Re: U.S. EPA's Comments
Draft Interceptor Well System Interim Corrective Measure (ICM)
Effectiveness Evaluation Dated June 30, 2009
Occidental Chemical Corporation
6200 Ridge Road, Wichita, Kansas
RCRA ID# KSD007482029

Conestoga-Rovers & Associates (CRA), on behalf of Occidental Chemical Corporation (OCC), has prepared responses to the United States Environmental Protection Agency (U.S. EPA) comments detailed in your letter dated September 24, 2009. For ease of your review, U.S. EPA's comments are reiterated below in italic print, followed by CRA's response.

Section: G - G'

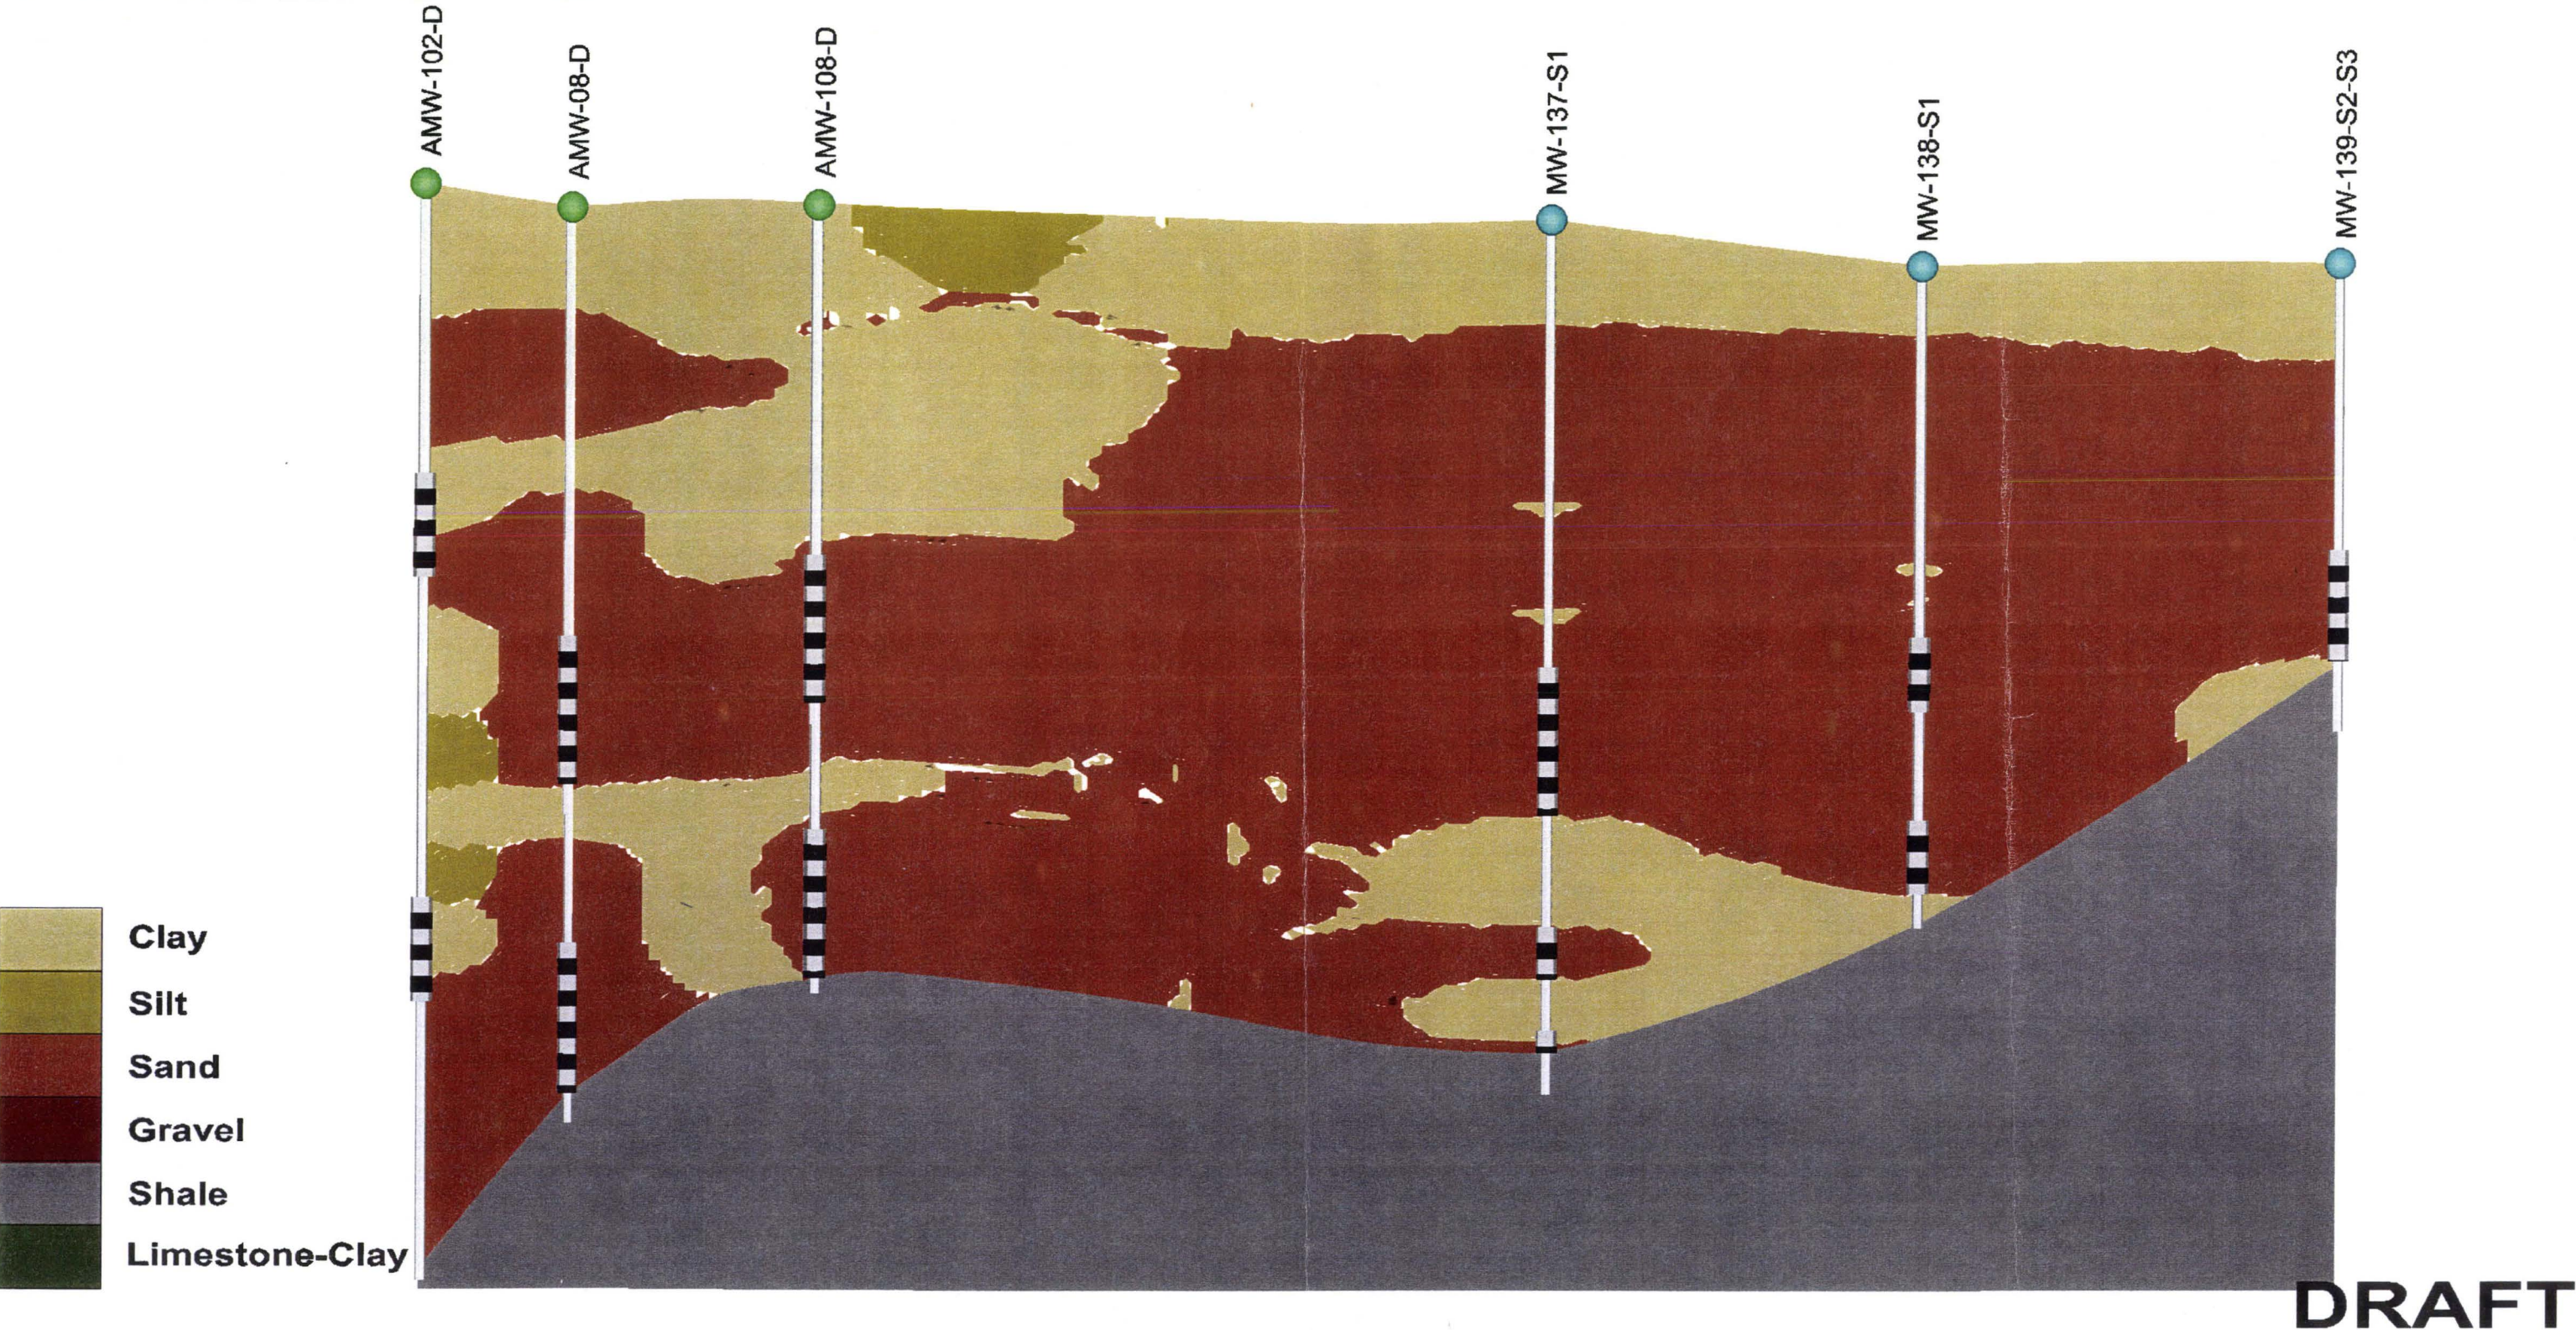
Table 10 lists monitoring well MW137S2 as screened in the S1 sand unit and monitoring well MW138S1 as screened in the S2/S3 sand unit. The sand units ascribed to these wells appear to contradict the sand units in which these monitoring wells were intended to be installed. Table 10 must be revised to correct the sand units attributed to monitoring wells MW137S2 and MW138S1, or confirmation must be provided that these sand units are correct.

Stratigraphic information from the well stratigraphic logs and groundwater elevation data was thoroughly evaluated to develop three dimensional interpretations of the subsurface conditions on a regional scale. This stratigraphic information was used to develop the geologic cross-sections presented on Figures 12 through 18 in the report. Figure 14, Geologic Cross-Section C-C', provides the rationale used to re-categorize monitoring well MW137S2 as being screened in the S1 sand unit. The two draft figures attached to this letter provide the rationale used to re-categorize monitoring well MW138S1 as being screened in the S2/S3 sand unit. The recommendations for the proposed ongoing groundwater monitoring program will be submitted to the EPA in a separate report.
